Access Compliance Report

Public Rights-of-Way

(Curb Ramps)

Intersection ID: 15360	Main Street: NEW_BERN_ST	Cross Street: RAIL_CROSSING_LN	Location: NE
ADA ID: 1FFDDFBE255D	Ramp Type: Perp	Initial Pass/Fail: Fail	Overall Compliance: No
Severity Score: 12.5			
Codes/Mitigation Info/Possible Solution		Field Measurements/Component Compliance

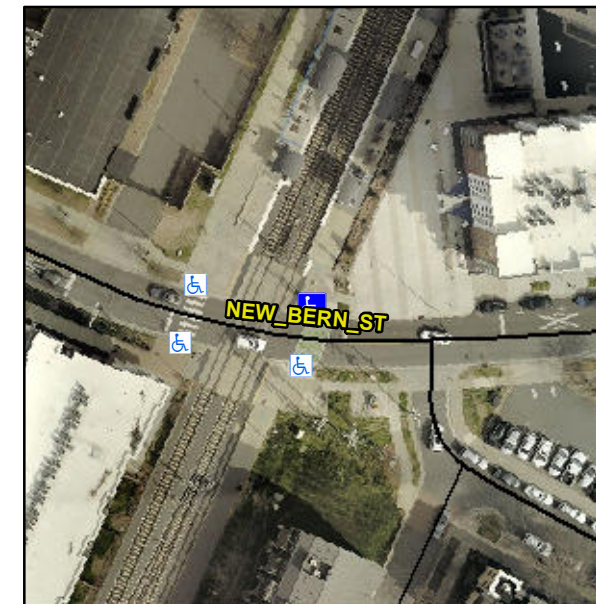
Not Found, R304.2.2

Compliance	Description	Data	Compliance	Description	Data
N/A	Ramp Length (in)	72.0	No	Ramp Slope (%)	8.9
Yes	Ramp Width (in)	156.0	Yes	Ramp XSlope (%)	1.6
N/A	Flare Type LT	N/A	N/A	Flare Type RT	N/A
N/A	Flare Slope LT (%)	N/A	N/A	Flare Slope RT (%)	N/A
N/A	Flare Traversable LT?	N/A	N/A	Flare Traversable RT?	N/A
N/A	Landing Length (in)	N/A	N/A	DWS Provided?	N/A
N/A	Landing Width (in)	N/A	N/A	DWS Contrast?	N/A
N/A	Landing Slope (%)	N/A	N/A	DWS Length (in)	N/A
N/A	Landing X Slope (%)	N/A	N/A	DWS Full Width?	N/A
N/A	Landing Curb? (Y/N)	N/A	N/A	DWS Offset (in)	N/A
N/A	Shared Landing?	N/A			
N/A	Gutter Ponding?	N/A	N/A	Gutter Slope (%)	N/A
N/A	Gutter Lip Ht (in)	N/A	N/A	Gutter X Slope (%)	N/A
N/A	Painted X Walk1?	Yes	N/A	Painted X Walk2?	N/A
	X Walk 1 Direction	To SW		X Walk 2 Direction	N/A
N/A	X Walk 1 Width (in)	156.0	N/A	X Walk 2 Width (in)	N/A
	X Walk 1 Slope (%)	1.6		X Walk 2 Slope (%)	N/A
	X Walk 1 X Slope (%)	1.7		X Walk 2 X Slope (%)	N/A

Remove & Replace Entire Ramp.
